**CITY OF SAINT PAUL  
HERITAGE PRESERVATION COMMISSION STAFF REPORT**

**FILE NAME:** 532 Ashland Avenue

**HPC SITE/DISTRICT:** Historic Hill Heritage Preservation District

**B. PROPOSED CHANGES:**

**Model 3001 Double Hung**

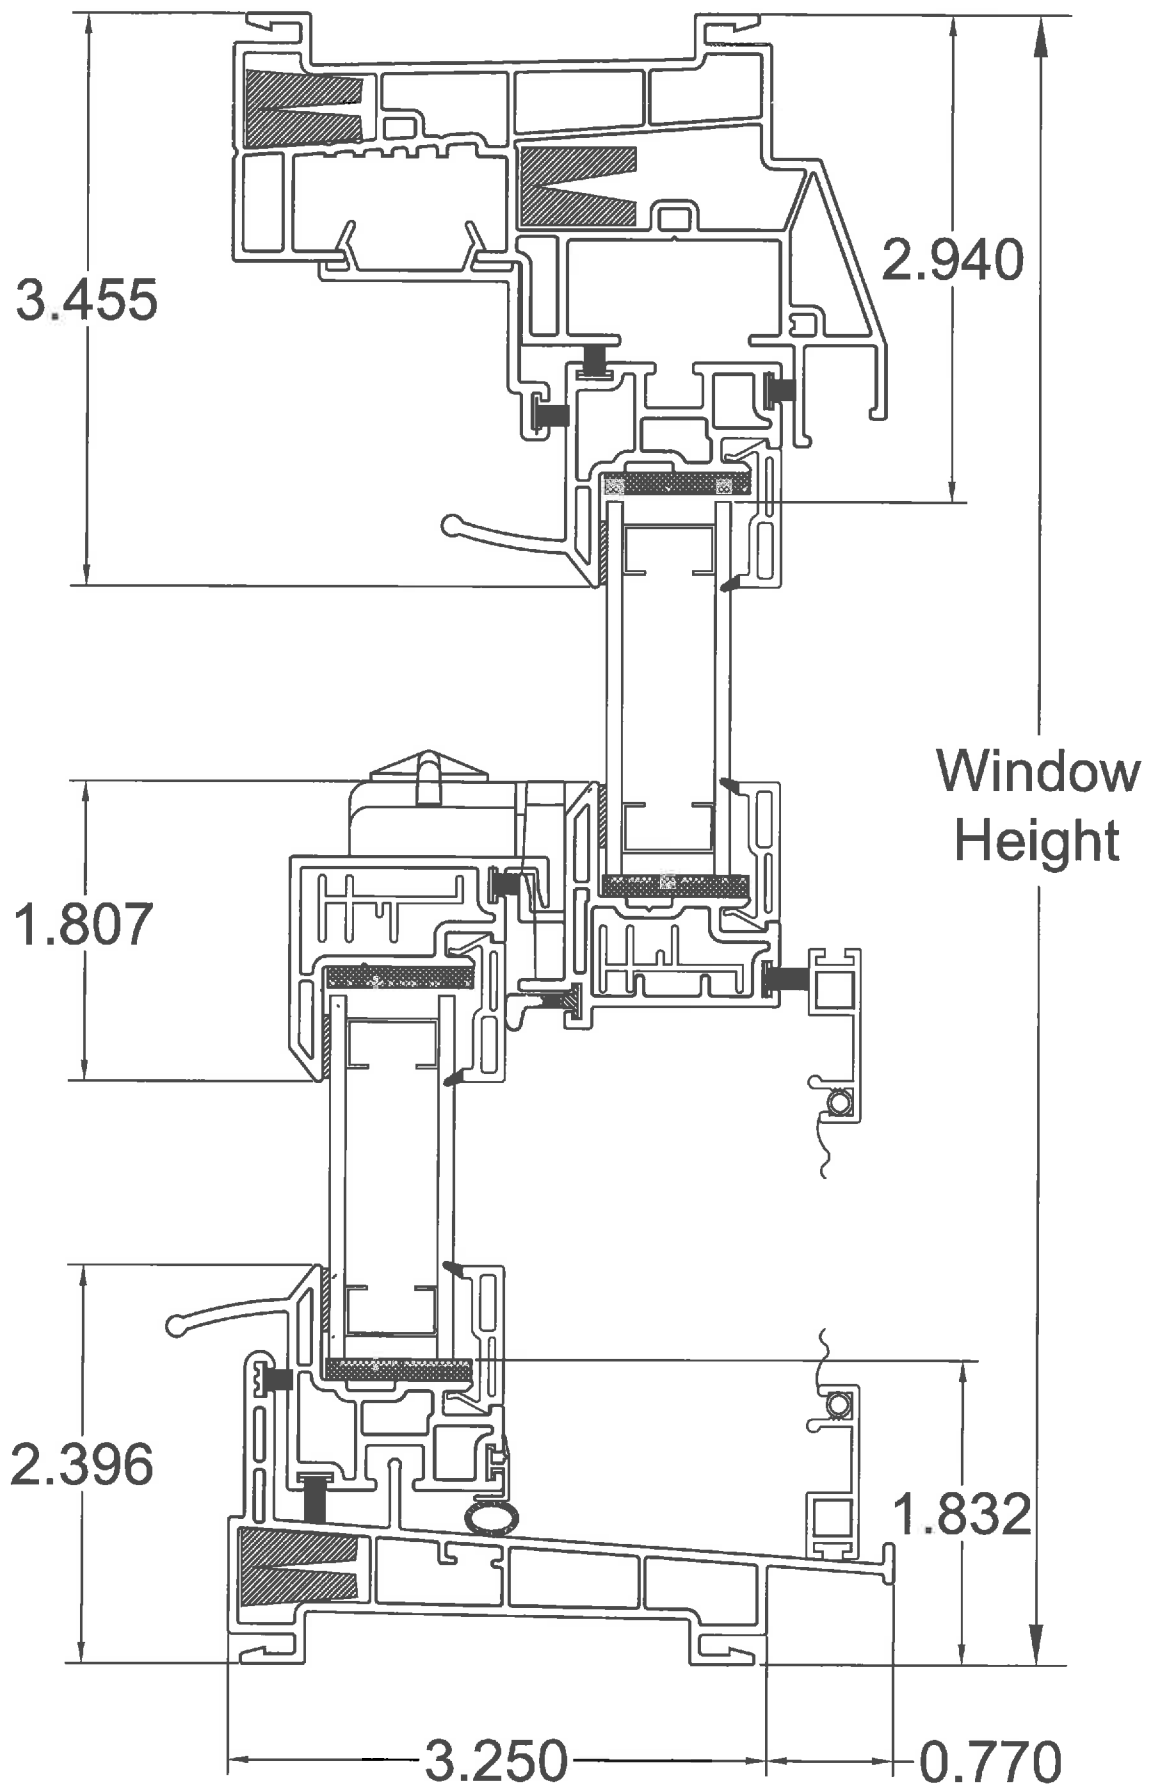
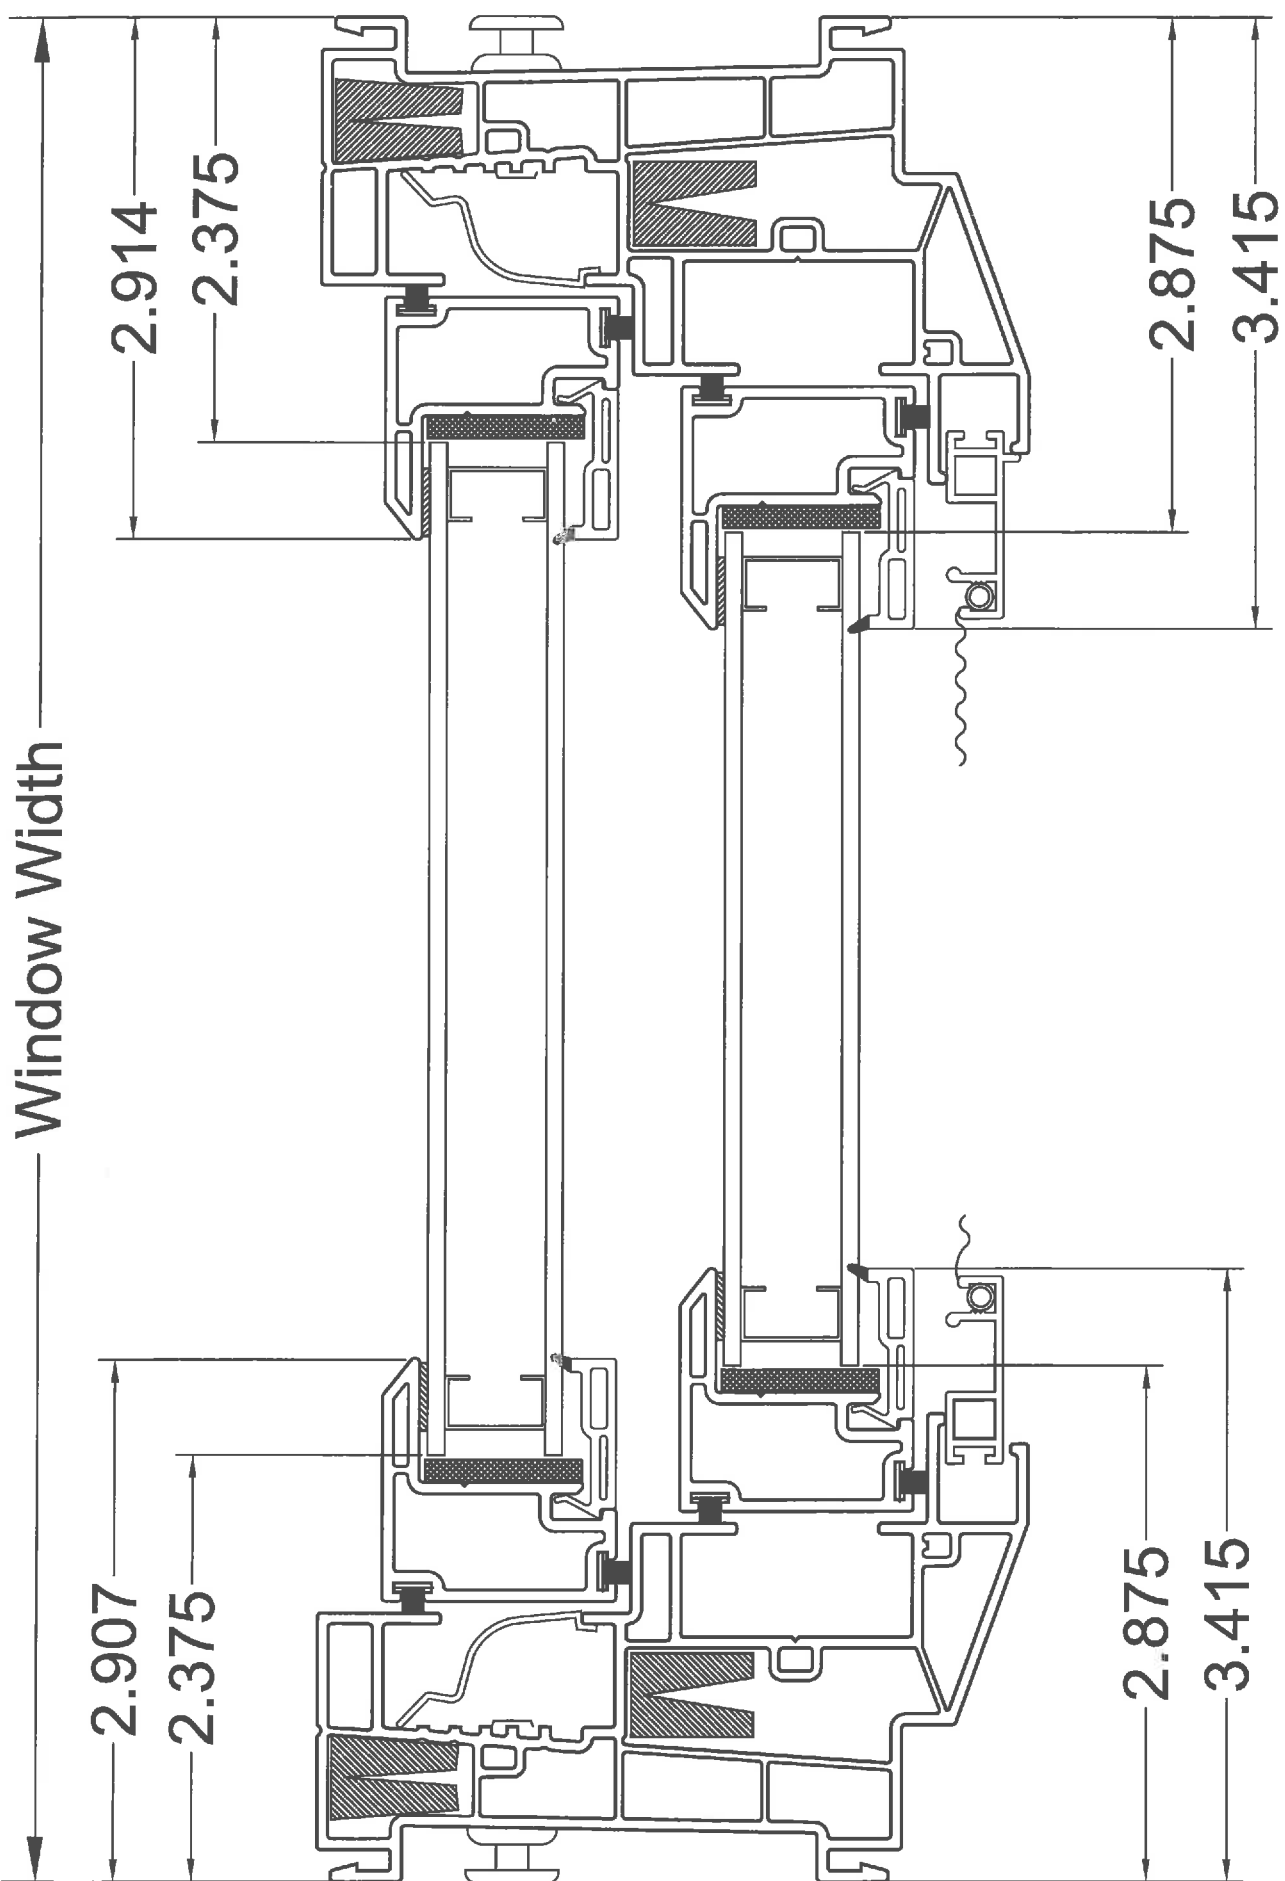
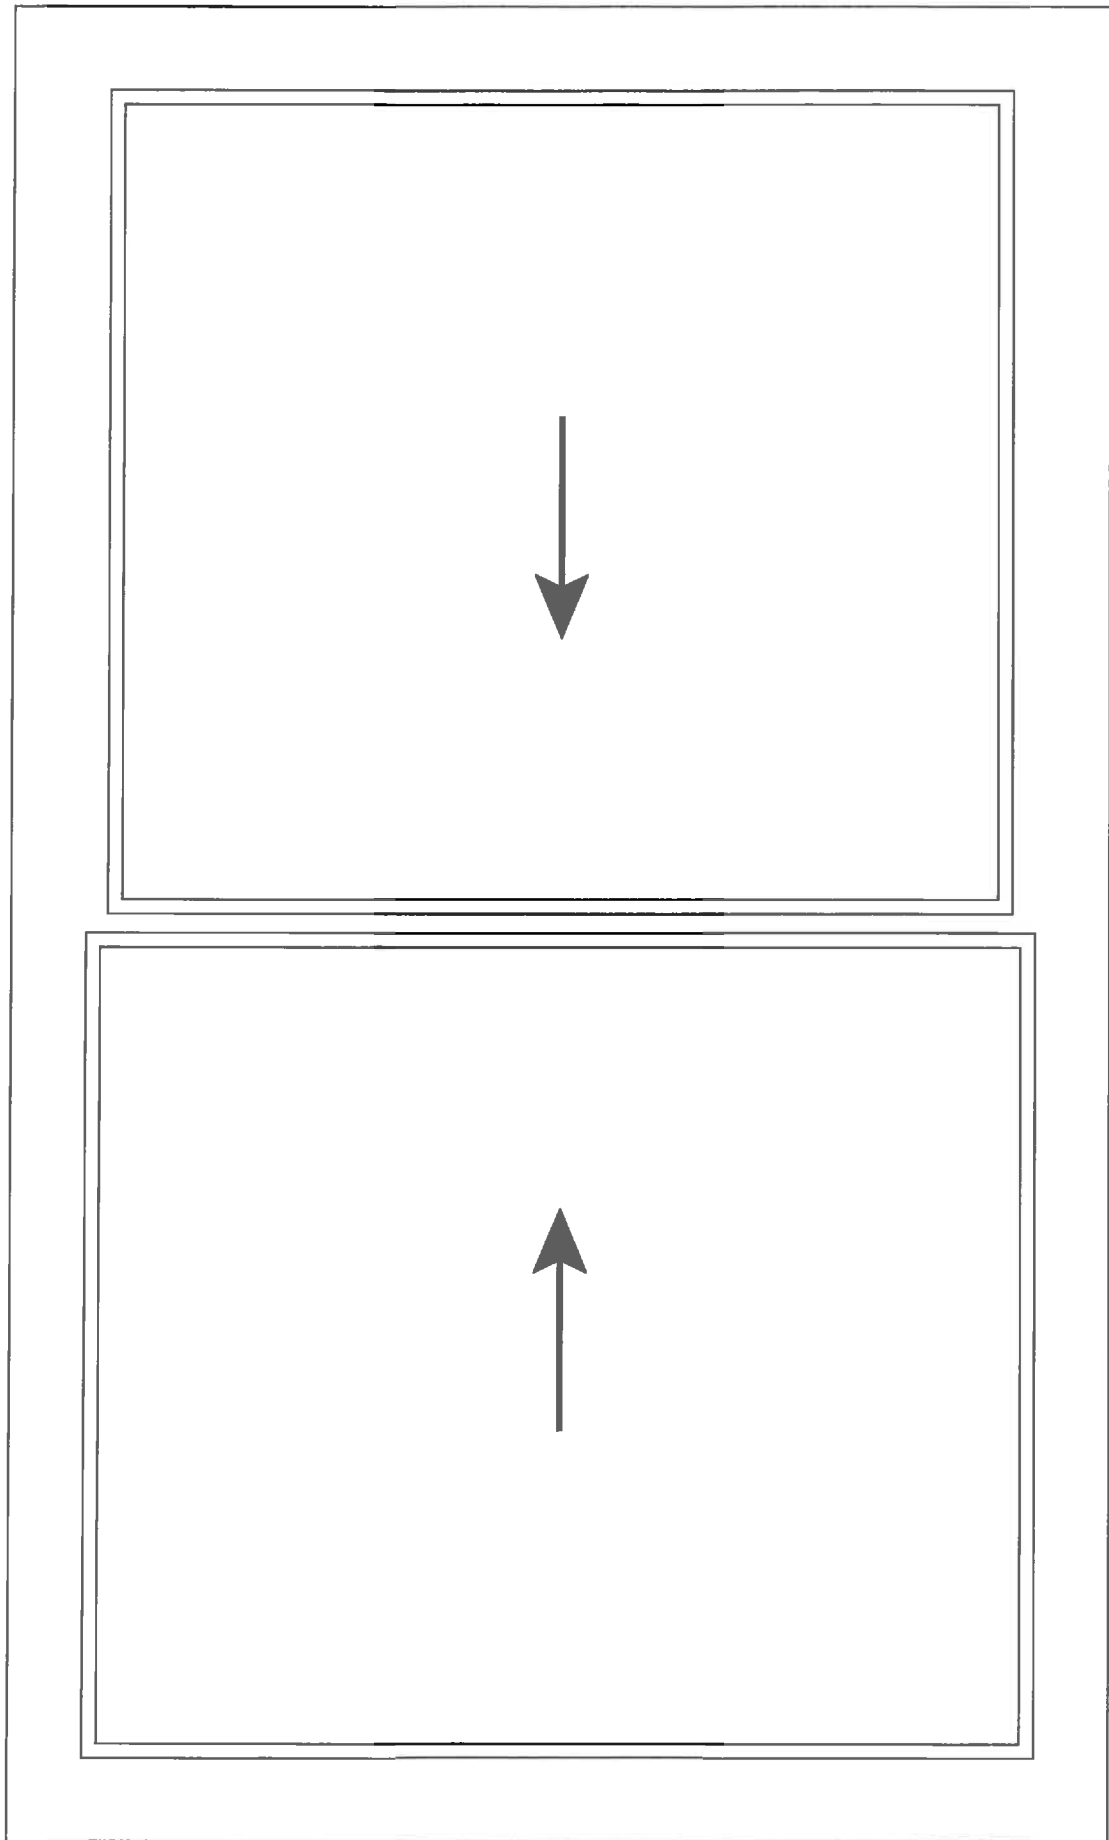
5. **§74.64(e)(1)** The proposed windows are full-frame vinyl inserts that would be installed in the existing frame (not the rough opening) and reduce the size of the opening and sash, thus not complying with the guideline that states *size of window panes or sash* which the guideline states *should not be altered. Such changes destroy the scale and proportion of the building.*

7. **§74.64(e)(3) Windows-** The proposed all vinyl replacement windows with half screens do not comply with the guidelines as they fail to *duplicate the material, design and hardware of the older window sash*. The rails, stiles, and meeting rail are thin and not of historic proportions and the frame is not flush, but has an exterior bevel.

Based on the findings, staff recommends a denial of the building permit application to replace wood windows with vinyl windows. Staff encourages the property owner to explore repair of the wood windows. Staff could review and administratively approve repair of the wood windows or in-kind replacement of the wood windows where replacement is justified.
